File No.: 04-1000-20-2018-452

A document that explains the current status of the development contemplated at 1503 Kingsway from March 1, 2018 to August 31, 2018.

RE: Pre Application Open House: 1503 Kingsway, April 5th, 2018

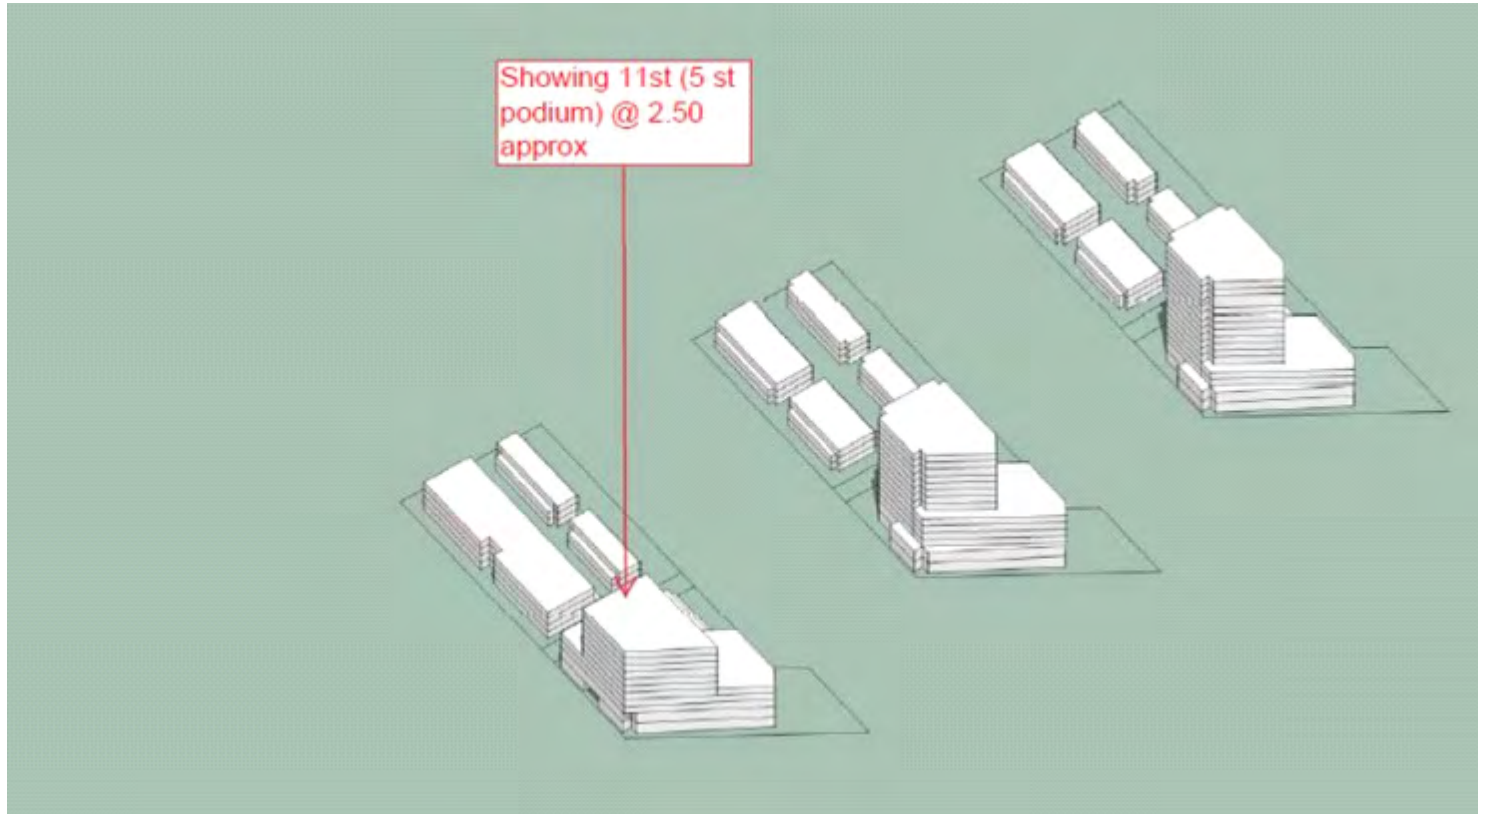
This is slightly different than your directions in our meeting with them on Thursday which were:

- **s.13(1)**
- Podium should be 6 storeys (not 4) on Kingsway with only the 6 floor setback on both Kingsway and the mini-park to the east
- Articulated apartment building can be supported. However if they provide so and they keep the 6st podium I noticed the tower height may be possible to be reduced based on my study below. Also note that they will be proposing two stacked storeys of commercial therefore the 6st podium would be taller than the potential rental 100 to the east.
